Addendum 126 – Regulation No. 127

Amendment 1

Supplement 1 to the original version of the Regulation – Date of entry into force: 22 January 2015

Uniform provisions concerning the approval of motor vehicles with regard to their pedestrian safety performance

Figure 8A

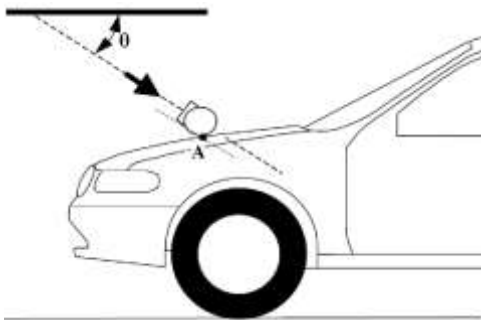
Insert new paragraphs 2.26. to 2.26.2. and new Figures 8A and 8B, to read:

- "2.26. "Measuring point"

The measuring point may also be referred to as "test point" or "impact point". In all cases, the result of the test shall be attributed to this point, independent of where first contact occurs.

- 2.26.1. "Measuring point" for the headform test means a point on the vehicle's outer surface selected for assessment. The measuring point is where the headform's profile contacts the vehicle's outer surface cross section in a vertical longitudinal plane through the centre of gravity of the headform (see Figure 8A).
- 2.26.2. "Measuring point" for the lower legform to bumper test and the upper legform to bumper test is located in the vertical longitudinal plane through the central axis of the impactor (see Figure 8B).

Measuring point in the vertical longitudinal plane through the center of the headform impactor (see paragraph 2.26.1. above)

Note: Due to the spatial geometry of the bonnet top, the first contact may not occur in the same vertical longitudinal or transverse plane which contains measuring point A.

Figure 3
Example of marking of HIC1000 zone and HIC1700 zone

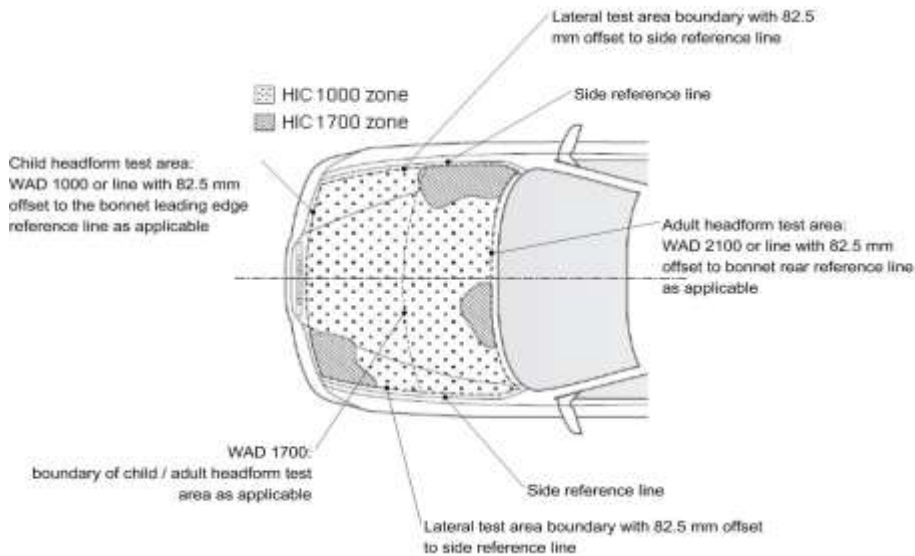
Paragraph 3.4.1., amend to read:

"3.4.1. The manufacturer ... of the bonnet top test area where the HIC ..."

Paragraphs 3.4.2. to 3.4.4., amend to read:

"3.4.2. Marking of the "bonnet top test area" as well as "HIC1000 zone" and ...
